Beaver Valley Power Station, Unit No. 2  
Docket No. 50-412, License No. NPF-73  
Response to NRC Staff Request for Additional Information Regarding Criticality  
Analyses Supporting a Spent Fuel Pool Re-rack for Unit 2 (TAC No. ME1079)

**Response to RAI on Unit 2 Spent Fuel Pool Re-rack Criticality Analysis**  
Page 1 of 36

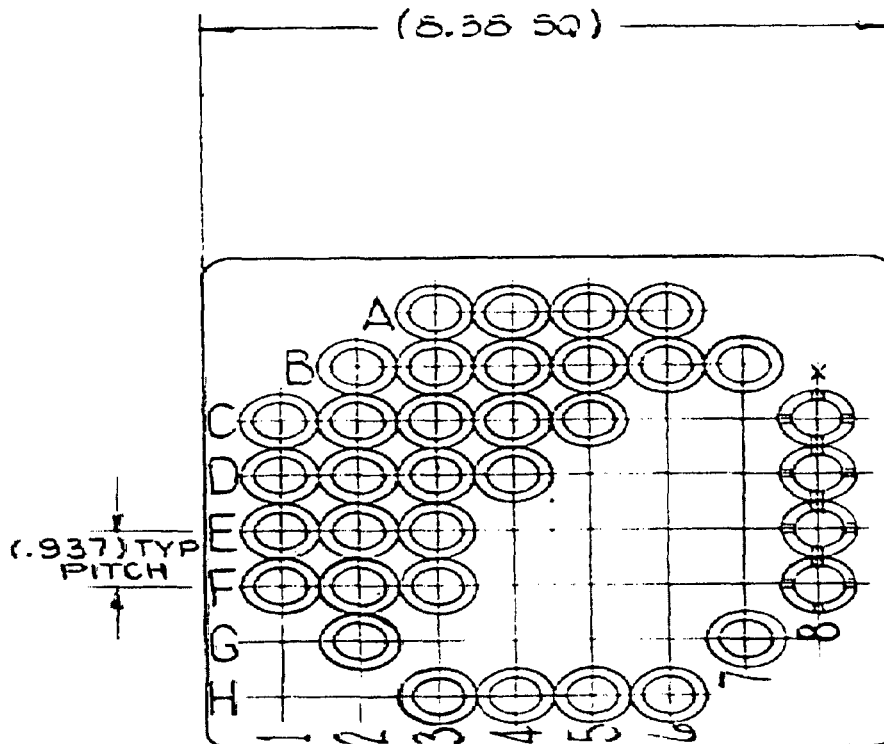
- 7. The text in Section 4.5.6 stated that racks are separated by a minimum 1.5-inch gap, but does not clearly define this dimension. This might be from the outside of the sheathing that holds the Metamic in place or it might be from the outside of each stainless steel box. Provide a clear definition of the 1.5-inch gap between racks and confirm that this definition is used in the calculations.**

The 1.5-inch gap between racks is defined by the 0.75-inch (+0.1875, -0.0 inch) base plate extensions and therefore is the rack wall to rack wall gap between the stainless steel boxes. The calculational models have been verified to represent this geometry correctly.

First Configuration, Case 1 Eccentric Positioning

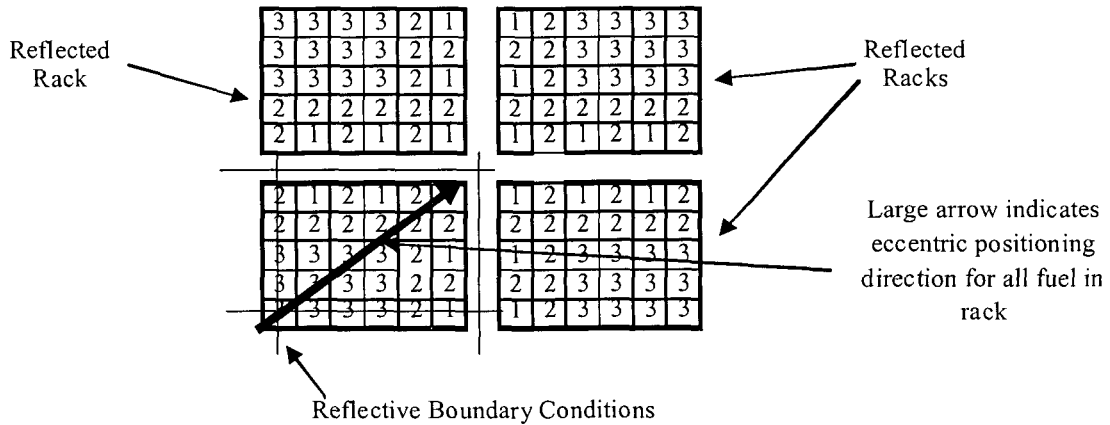
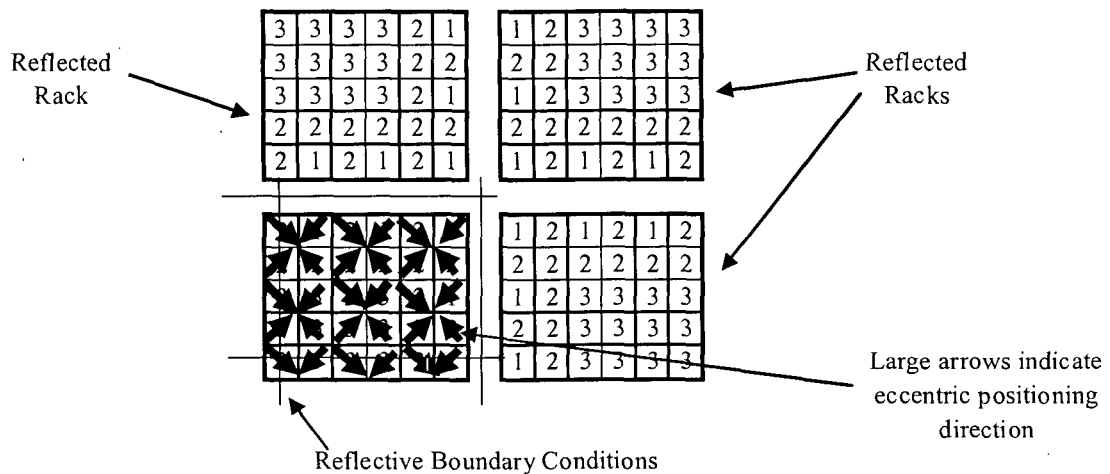
- 9. While it is unlikely to prove limiting, a case with all assemblies moved away from the storage rack center should have been evaluated in Section 4.7.6. This would move the highest reactivity fuel (5 wt% fresh fuel) in four adjacent rack corners toward each other. Expand the analysis to include this additional case or justify not doing so.**

This case was analyzed in the submitted analysis in Case 1. The text in Section 4.7.6 could have been more clearly worded as: "Case 1 models all the fuel assemblies eccentrically positioned away from the rack center so that there are four fresh assemblies in the four rack corners at their closest approach." A future supplement to the LAR will reflect the revised wording of Section 4.7.6.

For clarification, the following *partial* figure of Eccentric Case 1 is provided, with the point of the arrow being the location having four rack corners.

**First Configuration, Misloaded in Outer Row of Region 2**

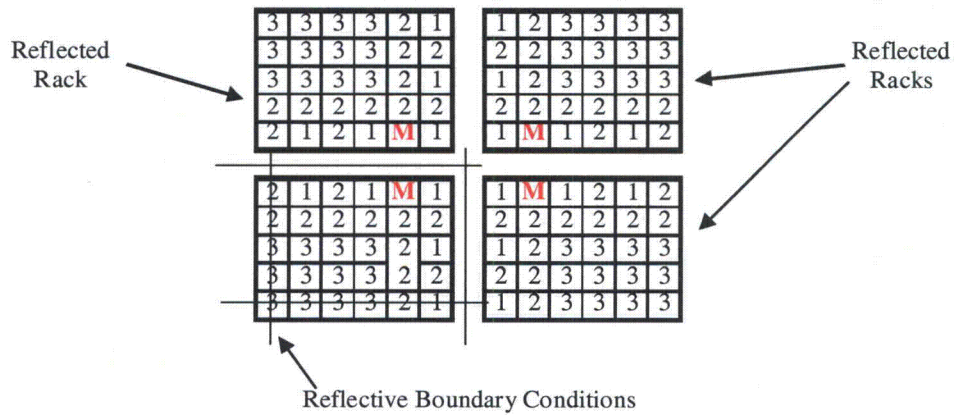
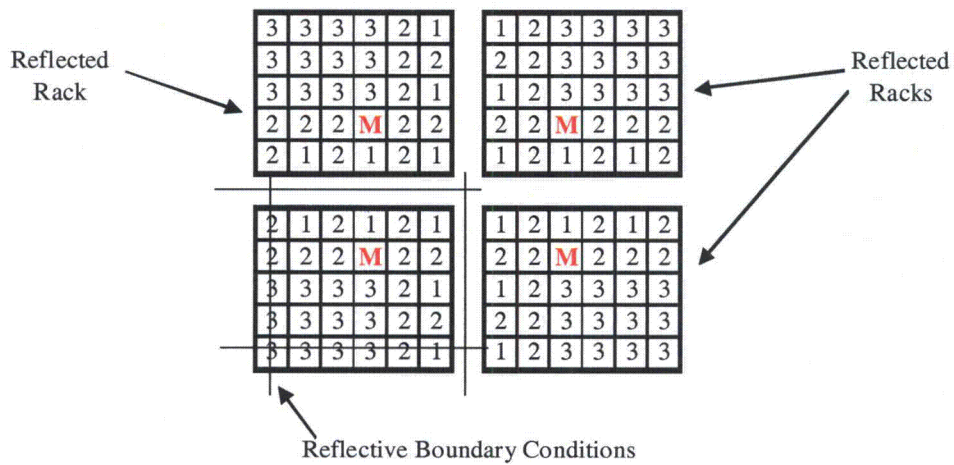
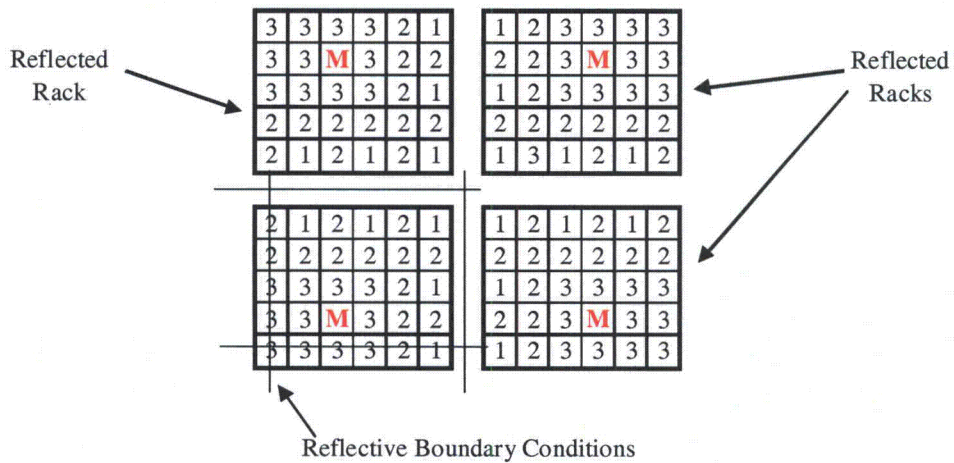
- 29. Section 4.7.13.4.1 described the analysis of misloaded fresh fuel assemblies. Provide the misloaded fuel assembly locations that were evaluated. If a limited set of positions were evaluated, justify use of the selected locations.**

The misloaded fuel assembly cases that were analyzed are described in Table 4.7.17 and the bounding case is shown in Figure 4.7.4. Additional figures are shown below for clarification of the three cases. These cases were selected because they bound the possibilities in the storage rack. For the bounding case, the misloaded 5.0 weight percent U-235 fuel assembly is face adjacent to three other 5.0 weight percent U-235 fuel assemblies. No other location in the storage rack would allow this configuration, and therefore, as the results show, it is bounding. For the other Region 2 location, the position was selected so that the misloaded assembly was face adjacent to the Region 1 cell, again bounding any other second row location. Both of these cases bound any possible Region 3 location, so the third case is arbitrarily chosen.
